Response to Agency Preliminary Comments on Labadie Energy Center §316(a) Draft Demonstration Study Report

Ameren Missouri has reviewed the comments provided by the Missouri Department of Natural Resources (MDNR) on behalf of the Agency and the Missouri Department of Conservation. It is our understanding that such comments also include feedback from Region VII of the United States Environmental Protection Agency (EPA) and the United States Fish and Wildlife Service (USFWS). Ameren also received comments from the EPA via email on December 4, 2019 from the MDNR. Ameren's responses to these comments are provided below. Some comments have also resulted in revisions to the Draft Demonstration Study Report and supporting materials (i.e., *Supplement to Labadie Energy Center Draft 316(a) Demonstration in Response to Agency Comments,* the "Supplement") which are referenced in the responses below. Ameren will plan to meet with MDNR in the near future to further discuss these comments and provide additional background.

Figure 1. Seasonal fraction of the fish community comprised of heat intolerant species as numbers (left) and biomass (right) in the vicinity of the LEC in 2017-2018.

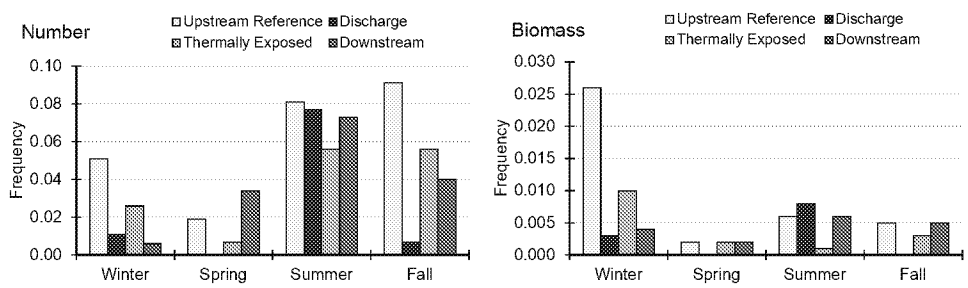
c. In addition to this, please graph these by season as Section 6.3.3 indicates certain intolerant species will be completely absent if the river exceeds certain temperatures. Seasonal density graphs were completed for the macroinvertebrate community in Figure 5-24.

c. Graphs in Section 5 were selected to illustrate patterns in the data, without overwhelming the reader with more graphics than can be assimilated. The seasonal aspect of the prevalence of heat tolerant and intolerant species was incorporated into the analysis. The data for tolerant and intolerant species, segregated by gear and season, are provided in Appendix B Tables B-14 through B-17. The standardized differences between Upstream and either Thermally Exposed or Downstream zones, based on each of these combinations for fraction intolerant species are provided in Appendix B Tables B-18 through B-21. All of the standardized differences for each combination of gear x season, for both numerical abundance and biomass (without preference) were included in the overall weight of evidence, along with differences based on other metrics, in Figure 5-22.

To satisfy the request, figures similar to Figure 1 are provided in the Supplement (Section 3) to demonstrate the seasonal component of heat-intolerant species as it relates to numerical abundance and biomass.

Figure 2. Maximum temperature at the edge of the 25% Mixing Zone vs. TDP

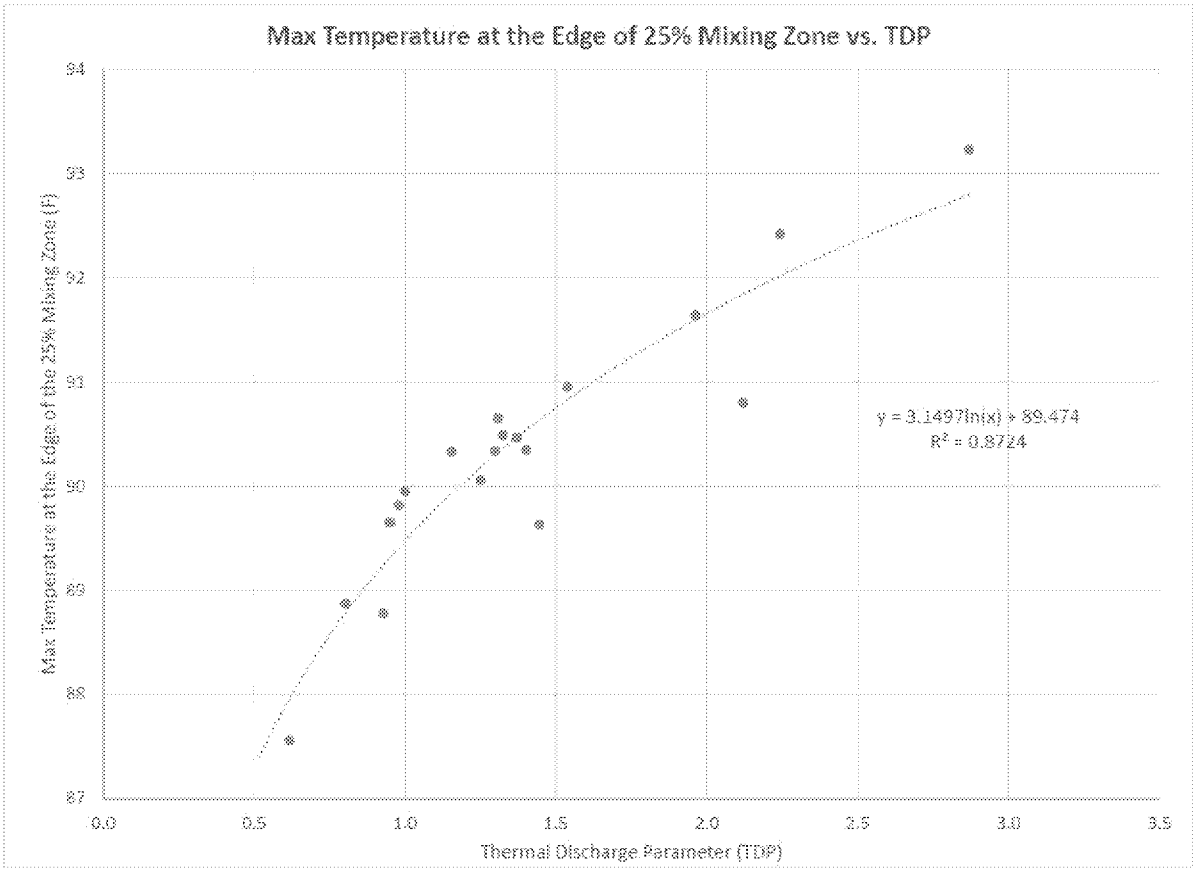
7. The Ameren variance request appears to be based on the logic of the Mississippi River criteria and this seems appropriate. The questions/comments below are based on that approach. While variable with river temperature, what is the more elevated temperature (>5°F) at the edge of the 25% mixing zone when the RMZ is expanded to 40% of the river? Does this equate to an additional 3°F increase above 90°F? Is the 40% value based on a calculated zone of passage or a maximum temperature at the higher RMZ? Ameren's variance request should define the increase in temperature above 90°F when the larger RMZ is allowed.

In response to this comment, we analyzed the model output from a subset of the previously conducted simulations that were run to develop the effluent limitation equations in Tables A-1 and A-2 of the NPDES permit. For each simulation, we determined the location along the river where the maximum temperature occurs after mixing with only 25% of the river flow. At all other locations, the temperature would of course be less than the maximum. The simulations analyzed represent a range of river and discharge temperatures and flows.

The results for the maximum temperature at the edge of the 25% mixing zone for each simulation are provided in the attached Figure. As expected, the Figure demonstrates that the maximum temperature is a function of the TDP. (Recall that the TDP is a composite measure of the combined effect of river and discharge flows and temperatures.) As can be seen, the maximum temperature at the edge of the 25% mixing zone will exceed 90°F at TDP values above 1, again as expected and as we have previously demonstrated. Nonetheless, the Figure further demonstrates that maximum temperature at the edge of the 25% mixing zone will always be below 94°F even for a simulation with TDP as high as 2.87. Analysis of the historical database (January 2002 – December 2018) indicates that TDP never would have exceeded 2.65. So, even when the variance may be invoked allowing temperature in the river to exceed 90°F in up to 40% of the river, the temperature will still be below 94°F in 75% of the river (i.e., be above 94°F in only 25% or less of the river), and will be below 90°F in 60% of the river (i.e., above 90°F in only 40% or less of the river). Furthermore, these maximum percentages will occur for only a small segment of the river and will be less at all other locations in the river.

For most instances during which the variance may be invoked the maximum temperature at the edge of the 25% mixing zone will only be one or two degrees above 90°F. For example, as shown in Figure 2, for a TDP value of 2.3, the maximum temperature at the edge of the 25% mixing zone will still only be about 92°F. And, TDP values at or above 2.3 would be extremely rare. The historical record shows that such has occurred on only 4 days out of 6018 days (less than 0.1% of the time). So, on days when the variance will be invoked, the maximum river temperature at the edge of the 25% mixing zone will typically be around one and almost always less than two degrees above 90°F, but never above 94°F.
